Since this drainage report is the same as that submitted for Filing No. 1, my comments are the same.

FINAL DRAINAGE PLAN

THE RIDGE AT LORSON RANCH

FILING NO. 1: SF 22-XX ← SF224

OUTLET STRUCTURE DETAIL - PLAN VIEW
NO SCALE

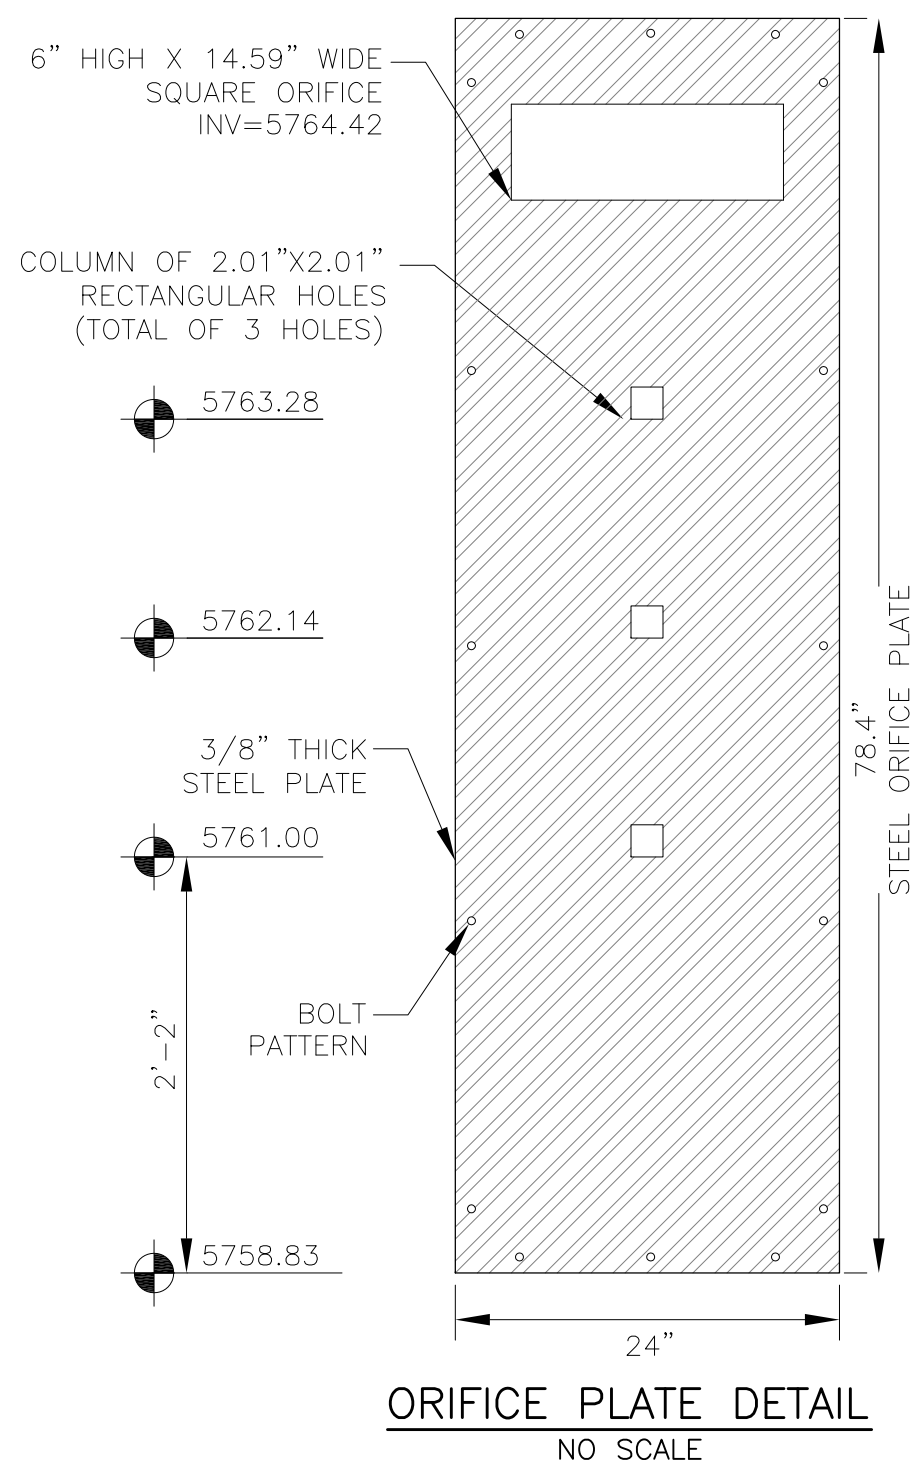
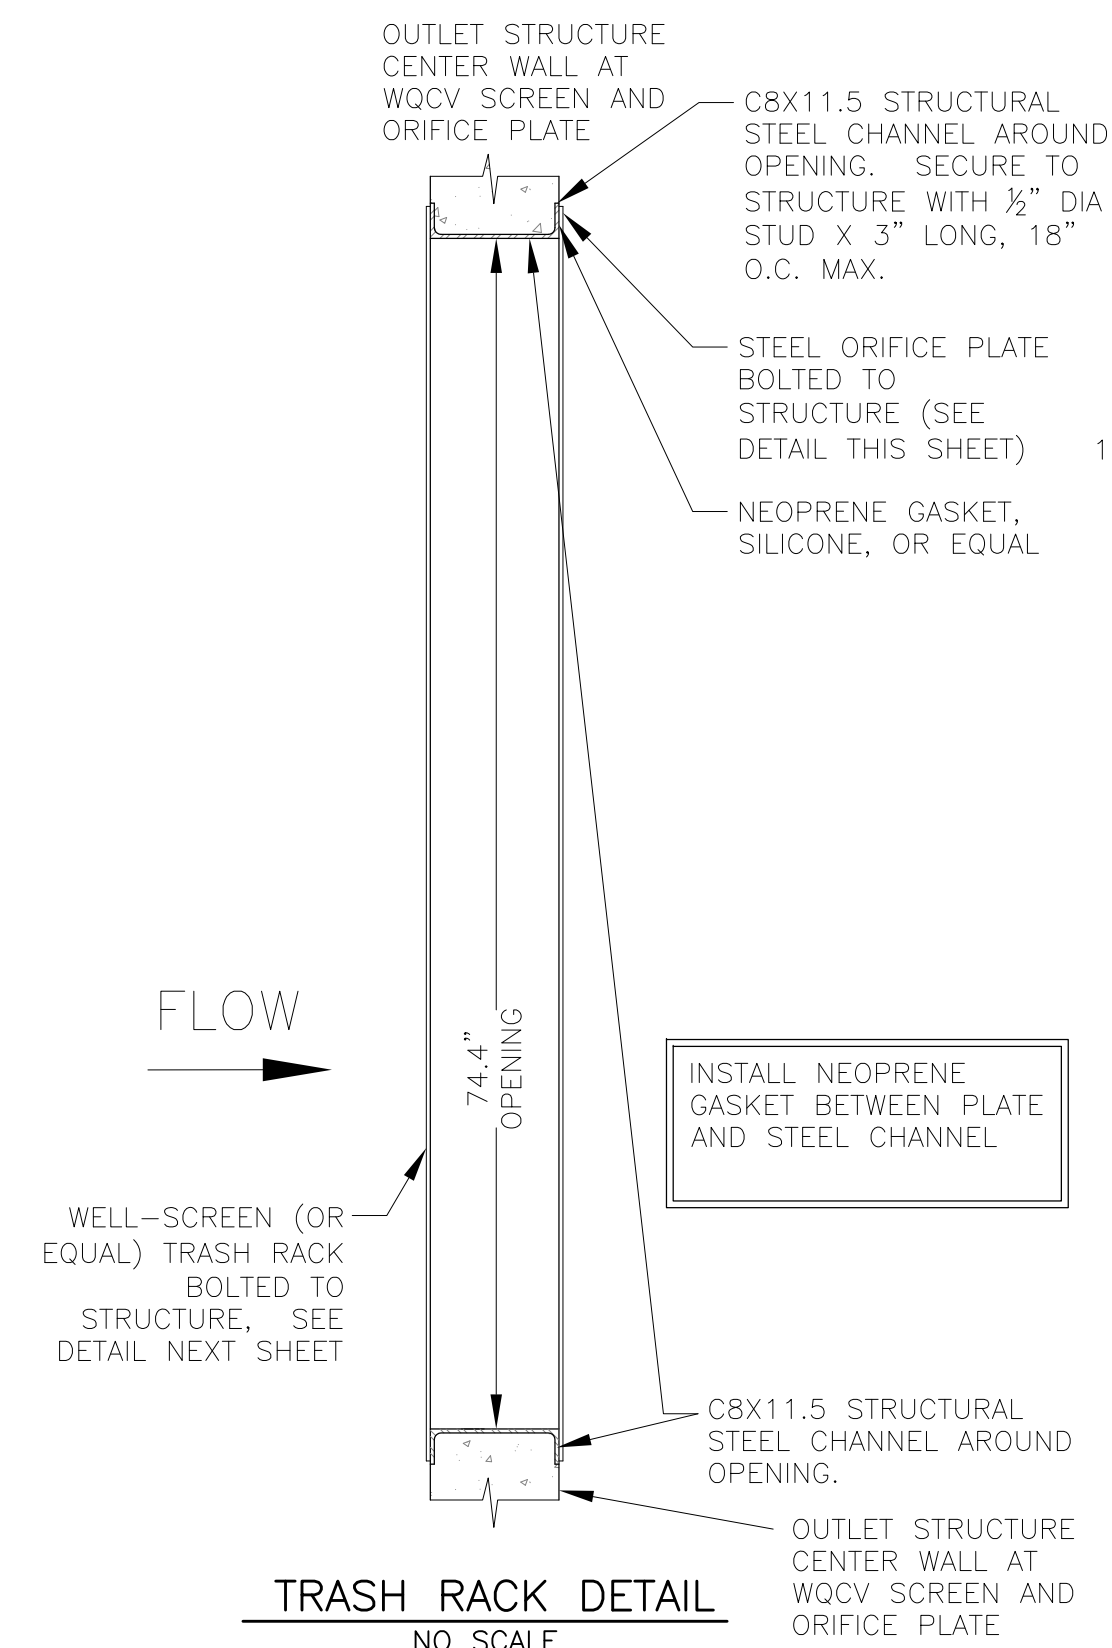
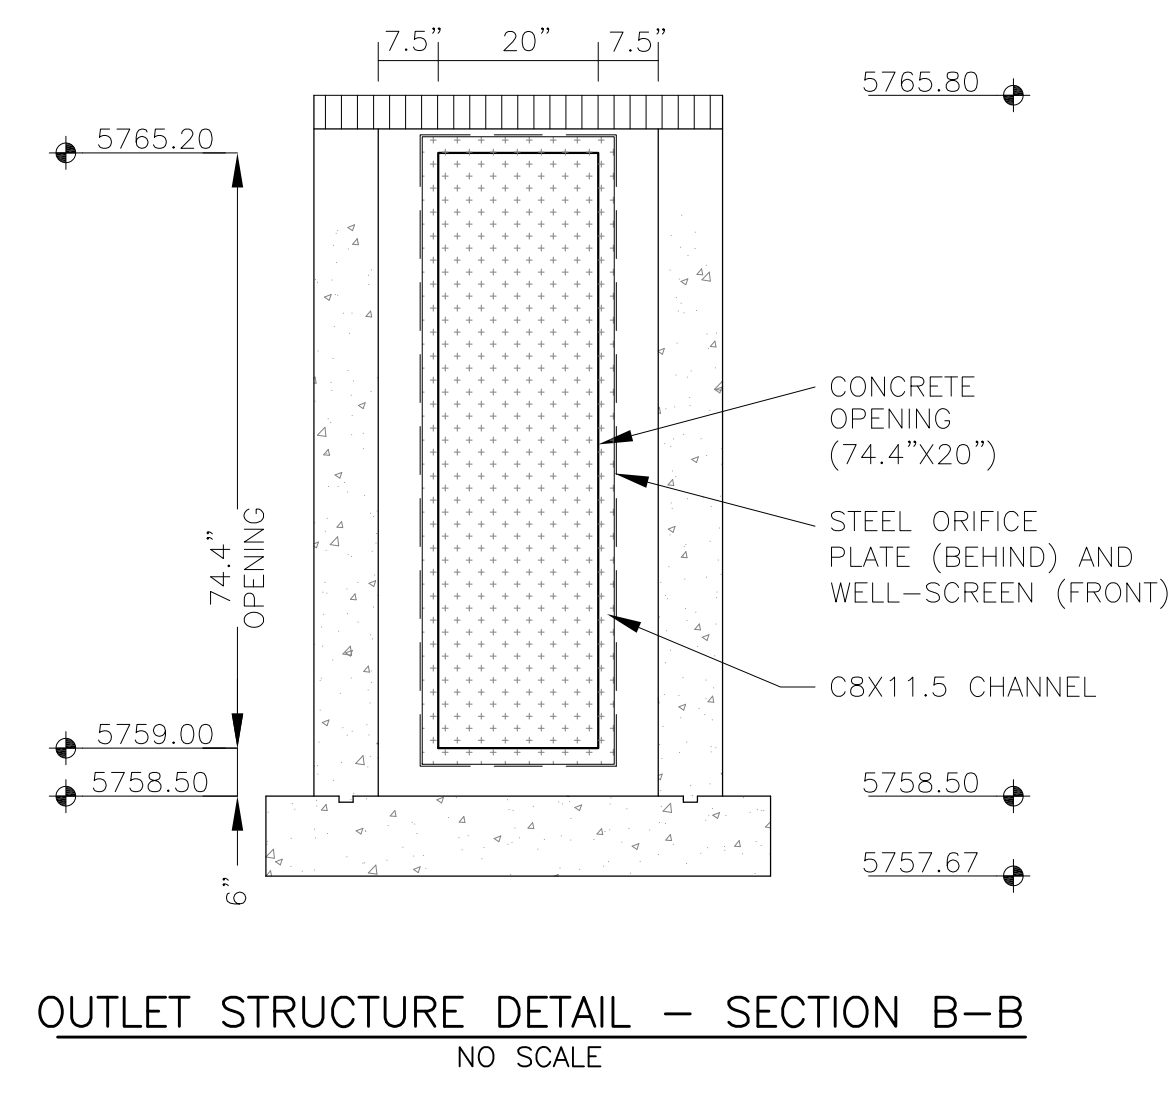
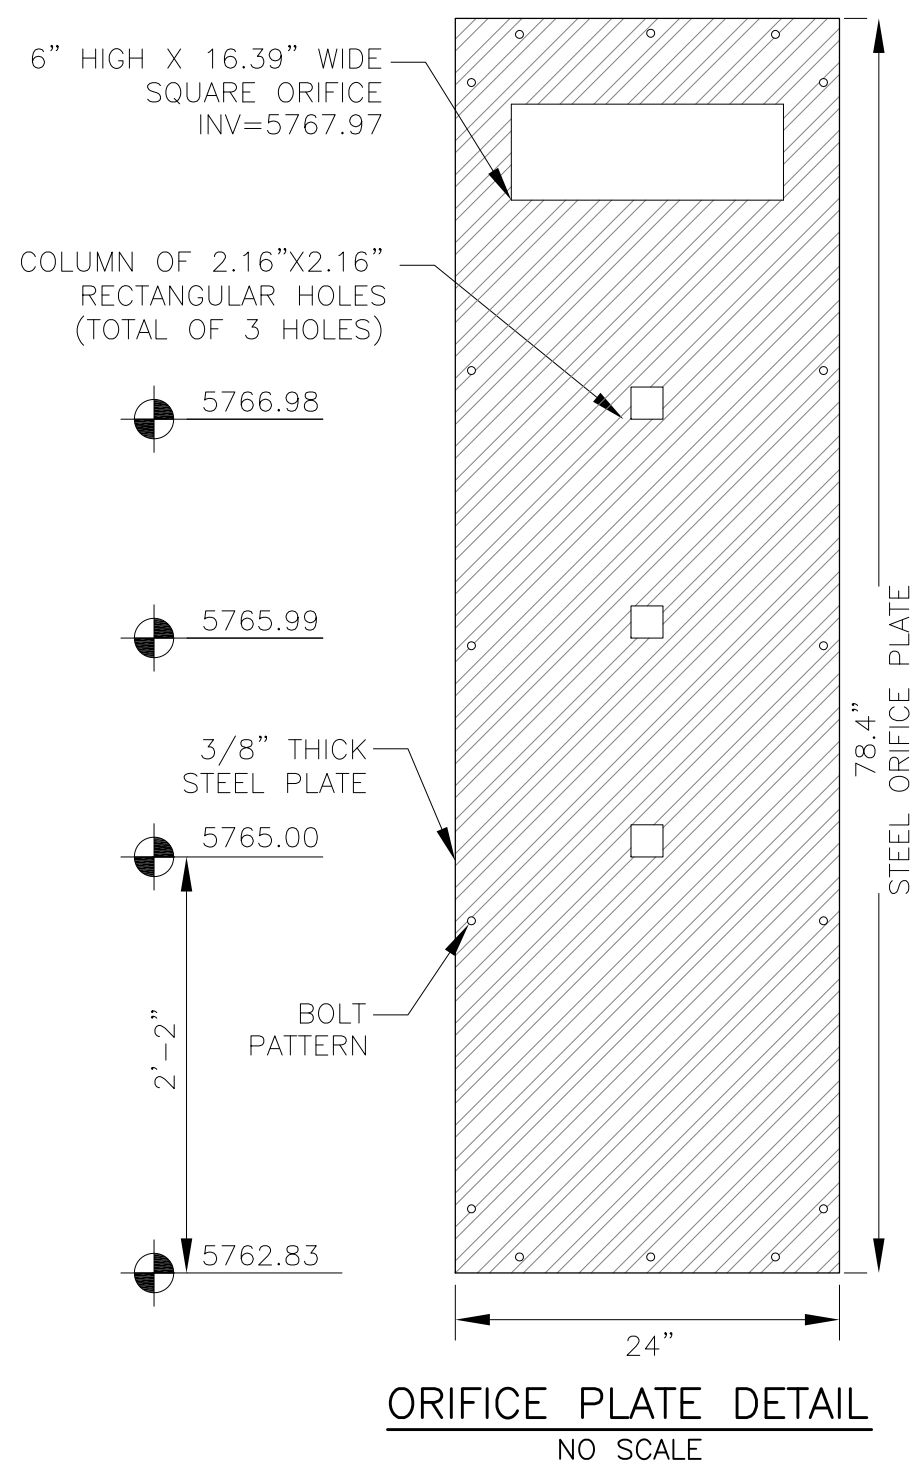
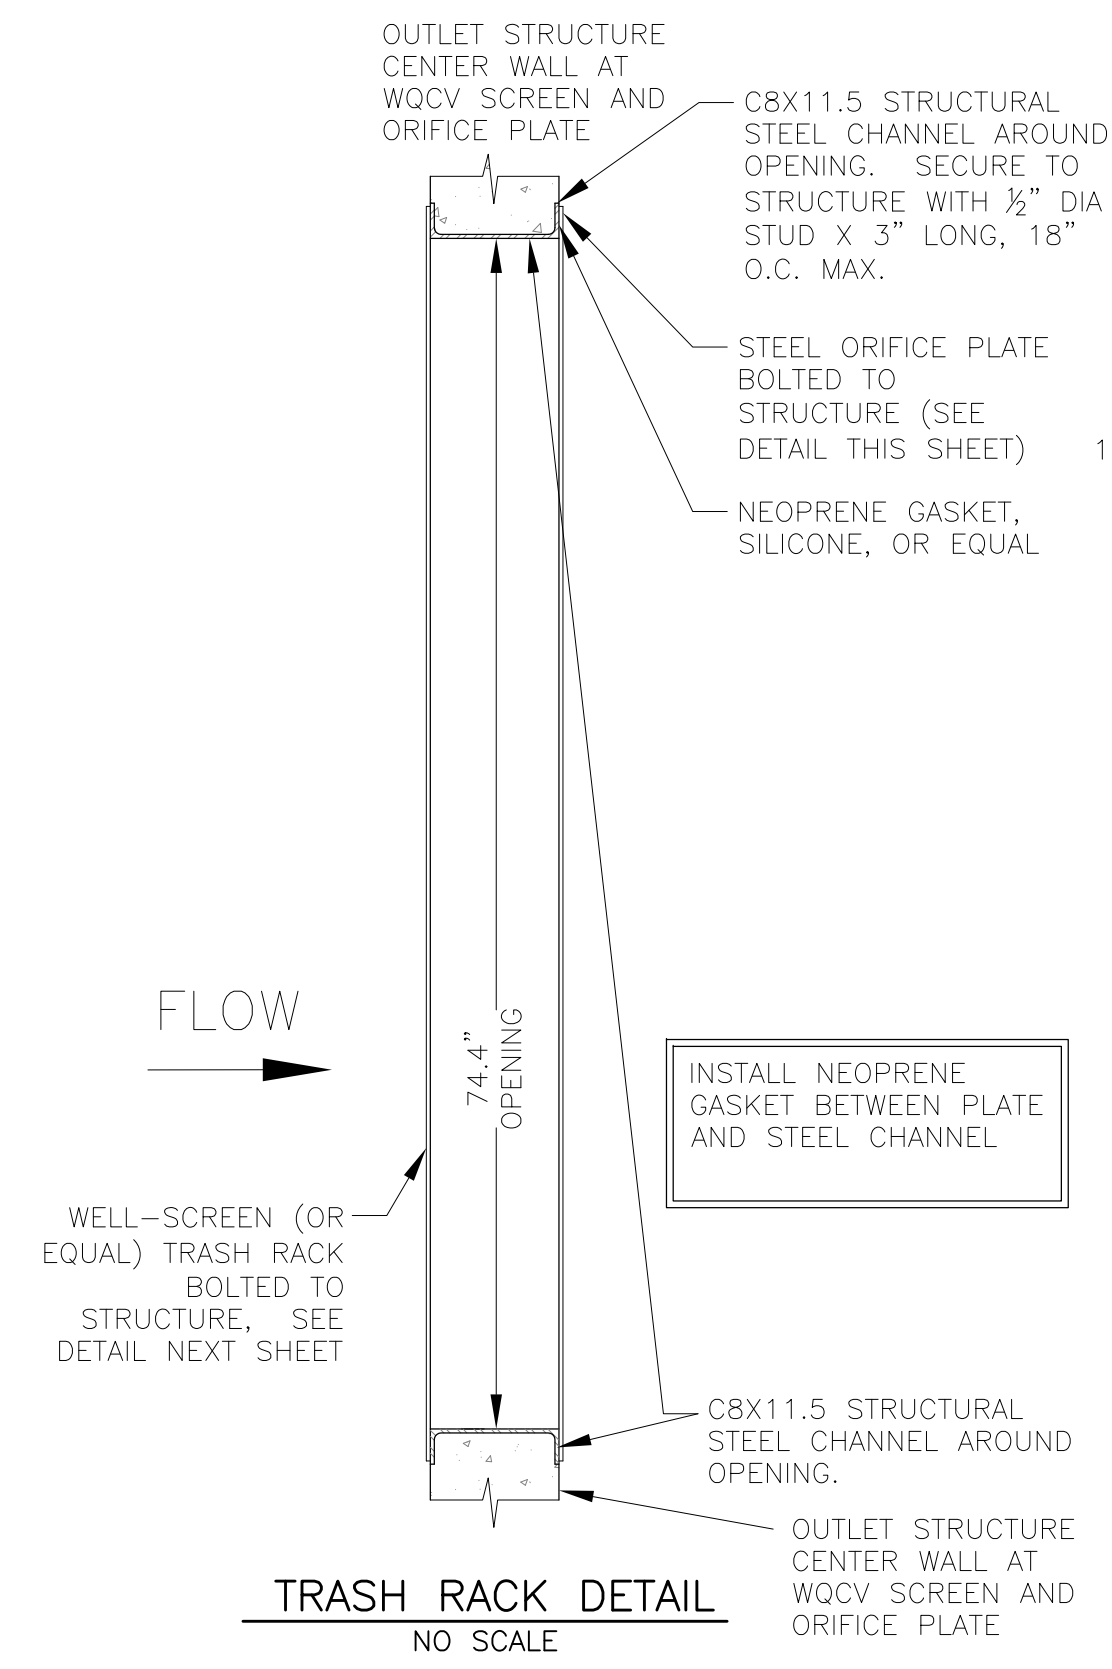
show dashed line for micropool walls (typical comment for the following two sheets as well).

MHFD Detail T-12 shows a 3\"/>

Consider potential maintenance difficulties with this outlet structure configuration. How will debris and sediment be removed from these two chambers since there is so much volume below the outlet pipe invert?
